No. 171

December 8, 2003

TECHNICAL BULLETIN

D90 TUMBLER CHANGE

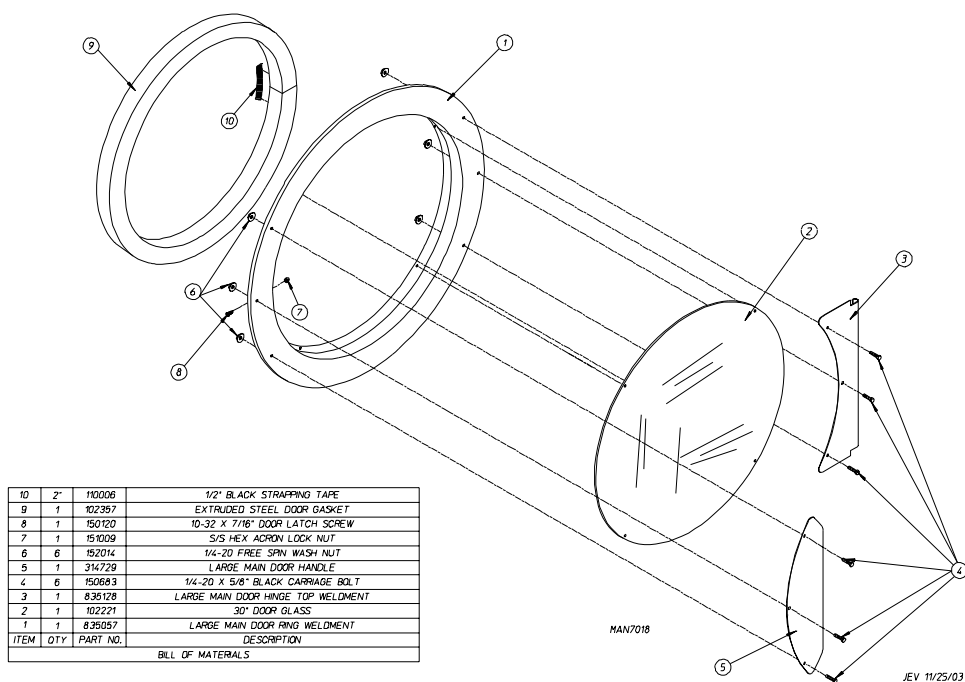
As of **December 1, 2003**, the D90 model dryer is no longer manufactured with a tumbler (basket) with an epoxy based Teflon (painted) finish. This model dryer is now manufactured with a stainless steel tumbler (basket).

AD-78 AND CG MEDIUM LINE MAIN DOOR CHANGE

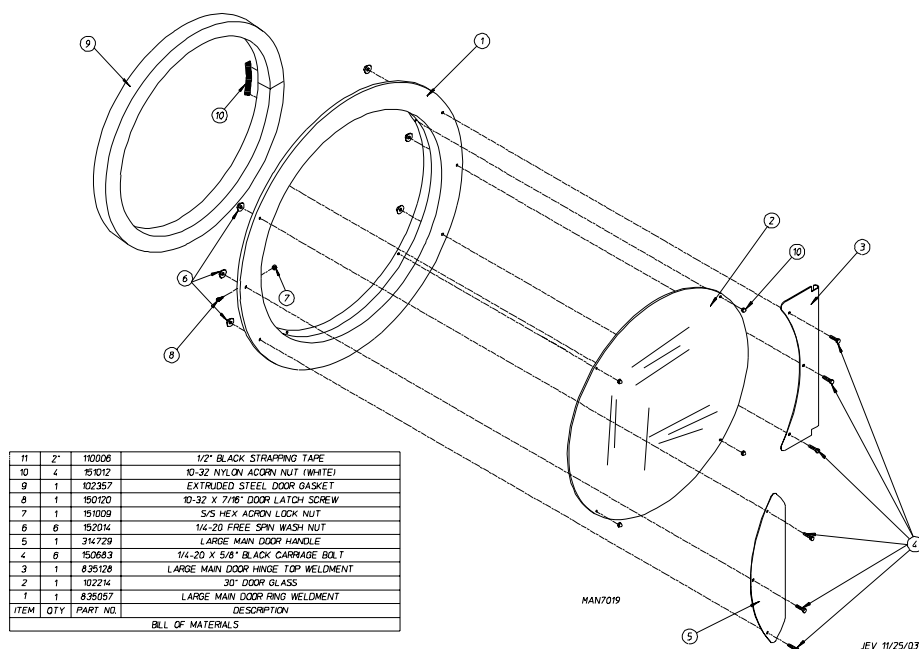
The studs and nylon acorn nuts (White **ADC** P/N 141012 or Black **ADC** P/N 141013) used to secure the glass in place have been deleted from our 31-1/4" CRS Main door, which is used on the models AD-78, AD-60 (WASSALON), CG115-25, CG145-55, CG165-75, and CG190-00. The glass is now secured in place with a silicone type of adhesive. As the result of this change, the main door glass has changed as well (holes eliminated) from **ADC** P/N 102214 to **ADC** P/N 102221 (glass without holes). This change was implemented in production on **November 6, 2003** and affects all related main doors assemblies, BOTH production and parts orders.

ADG-24 DIRECT SPARK IGNITION (DSI) MODULE CHANGE

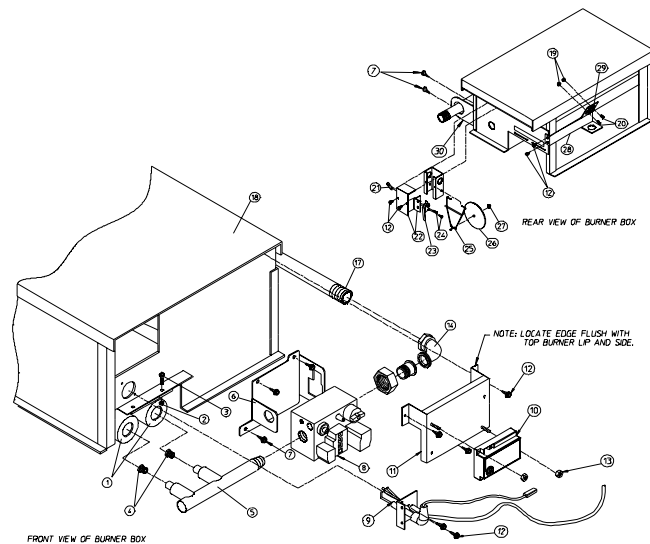
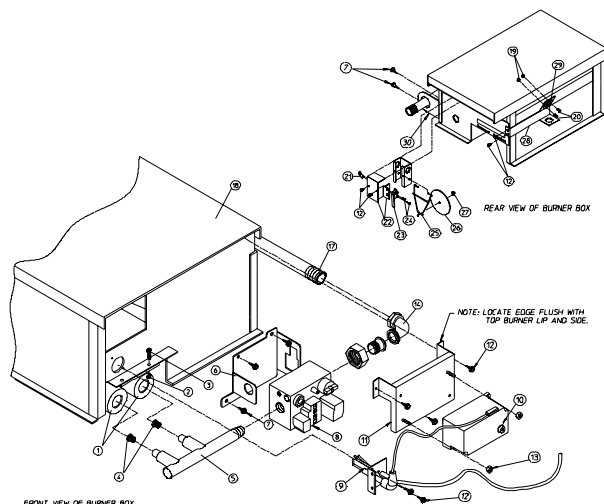
The model ADG-24 (GAS) manufactured as of **November 24, 2003**, has a different type of Direct Spark Ignition (DSI) module, mounting bracket, and High Voltage (HV) wire. The Johnson Controls DSI Module (**ADC** P/N 801048) for this model dryer has been replaced with our alternate vendor (Fenwal) DSI module (**ADC** P/N 128937). As the result of this DSI module changeover the DSI mounting bracket has changed (mounting stud foot print differs). In addition, the High Voltage (HV) wire has also changed, as now the termination to the Fenwal module is made with a 1/4" female spade terminal, as opposed to a non-terminated stud connection to the Johnson Controls DSI module. Due to these differences the Fenwal (**ADC** P/N 128937) CANNOT be used as a direct replacement for existing dryers in the field manufactured with the previously used Johnson Controls DSI module (**ADC** P/N 801048).

The drawings below are ONLY of the natural gas burner assemblies and are for comparison purposes only.

D170 GAS/STEAM BLOWER MOTOR ASSEMBLY CHANGE

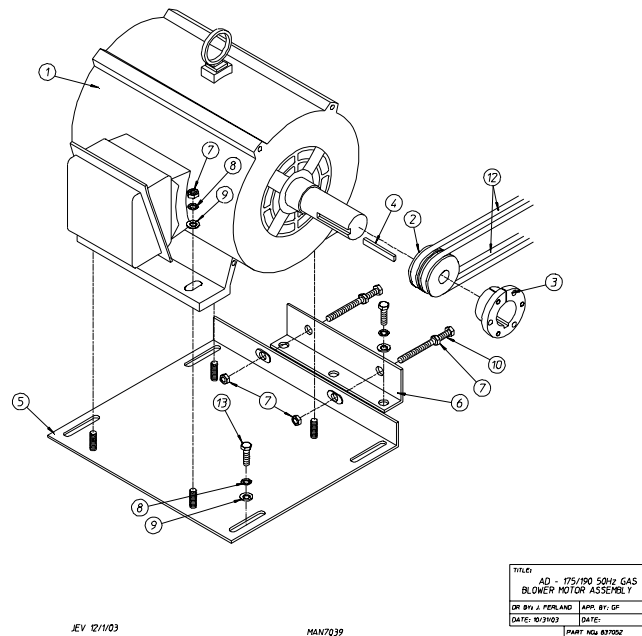
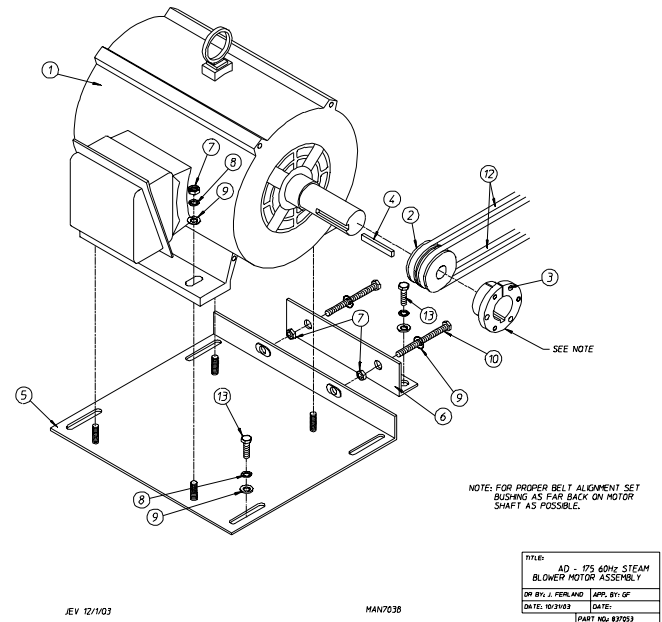
The blower motor assembly used on the gas (50 Hz ONLY) and steam (60 Hz ONLY) model D170 has changed as of **November 11, 2003**. The motor sheave and bushing have changed, and as the result, the assembly differs. Drawings below are of the current arrangement.

SHEAVE 4.4 **ADC** P/N 101195
BUSHING **ADC** P/N 101152
ASSEMBLY **ADC** P/N 837052

SHEAVE 4.4 **ADC** P/N 101195
BUSHING **ADC** P/N 101152
ASSEMBLY **ADC** P/N 837053

SHEAVE 4.8 **ADC** P/N 101147
BUSHING **ADC** P/N 101194
ASSEMBLY **ADC** P/N 837028

SHEAVE 4.0 **ADC** P/N 101148
SAME
ASSEMBLY **ADC** P/N 835298

The new motor mount assembly can be used as a direct replacement for models manufactured prior to this change. Again, this change only affects the 50 Hz GAS AND 60 Hz STEAM versions of D170 model only.

MEDIUM RANGE DRYER S.A.F.E. SYSTEM CHANGE

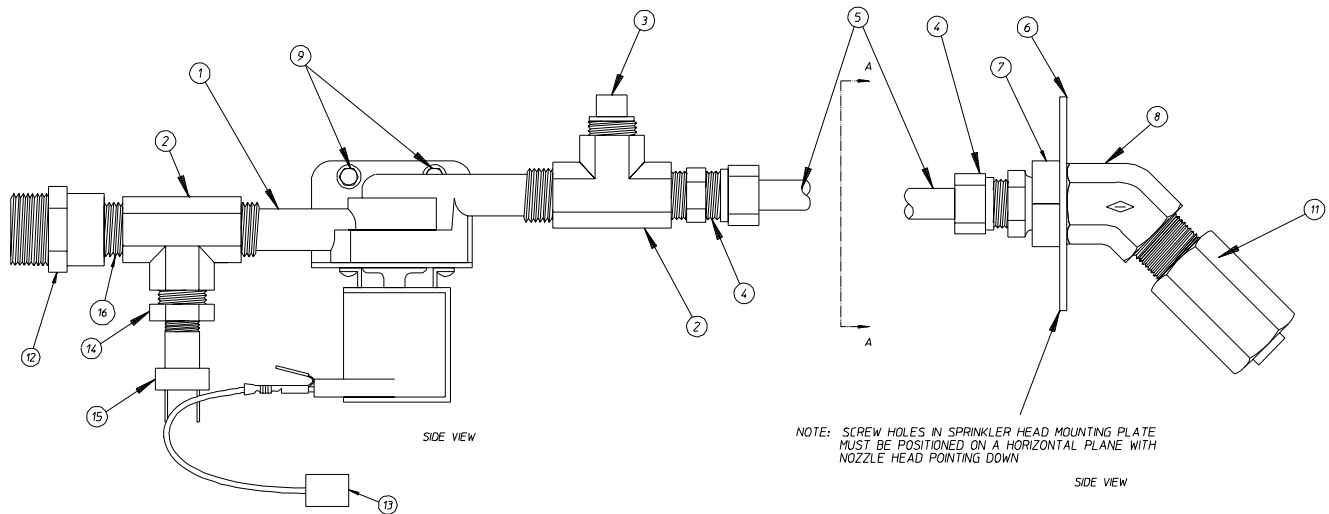
A slight change has been made to the medium dryer range Sensor Activated Fire Extinguishing (S.A.F.E.) system piping arrangement where for ease of assembly and service, the 3/8" close nipple (refer to Illus. no. 16 in drawing) used at the brass tee has been replaced with a 3/8" brass "hex" nipple. This change was implemented in the models AD-120, AD-170, CG115-25, CG145-55, CG165-75, CG190-00, D90, D120, D170, AND STI-45 on **Decemeber 2, 2003**.

The 3/8" brass "hex" nipple (**ADC P/N 182579**) can be used as a direct replacement for the previously used 3/8" close nipple (**ADC P/N 143241**).

D120 FRONT PANEL CHANGE

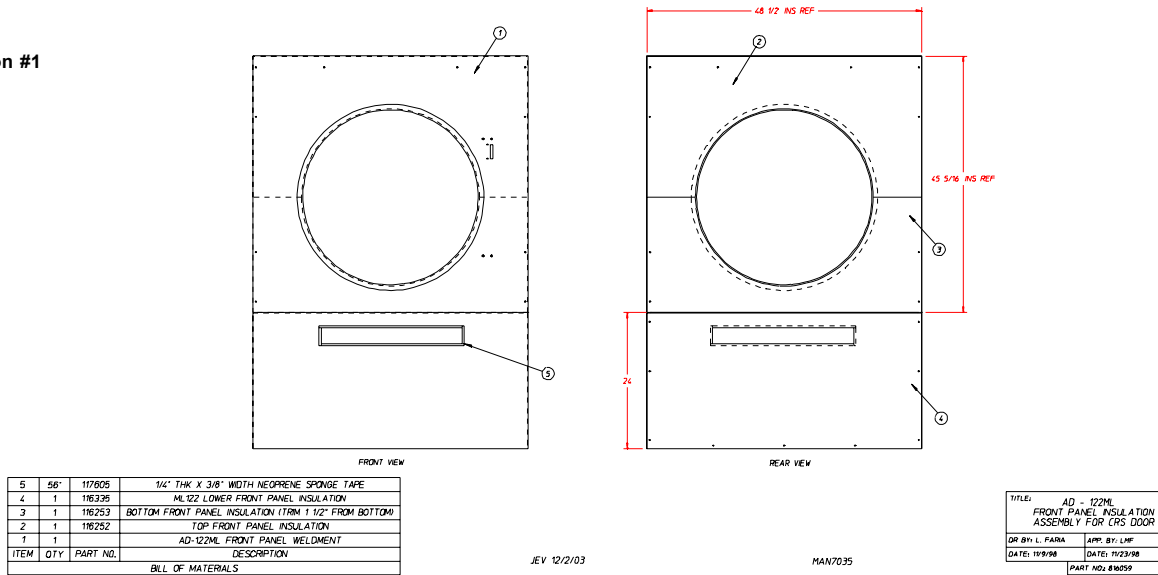
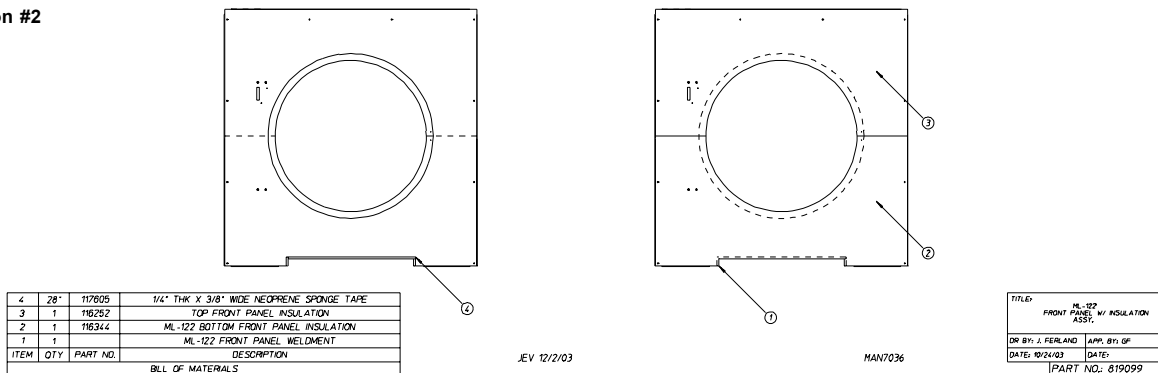
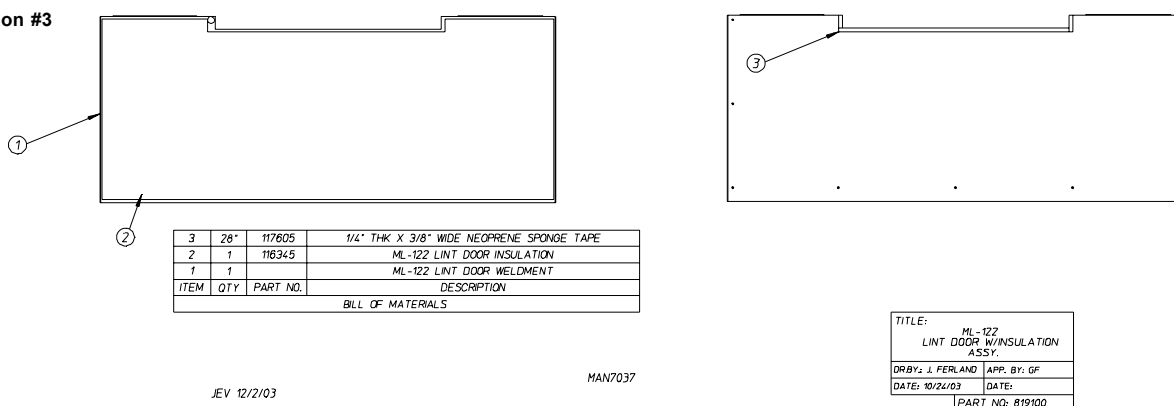
The D120 front panel has been redesigned to include two (2) pieces that can be removed independently. Illustration #1 shows the one piece front panel arrangement used in production prior to **December 2, 2003**. Illustrations #2 and #3 show the new two (2) piece front panel and lint door arrangement.
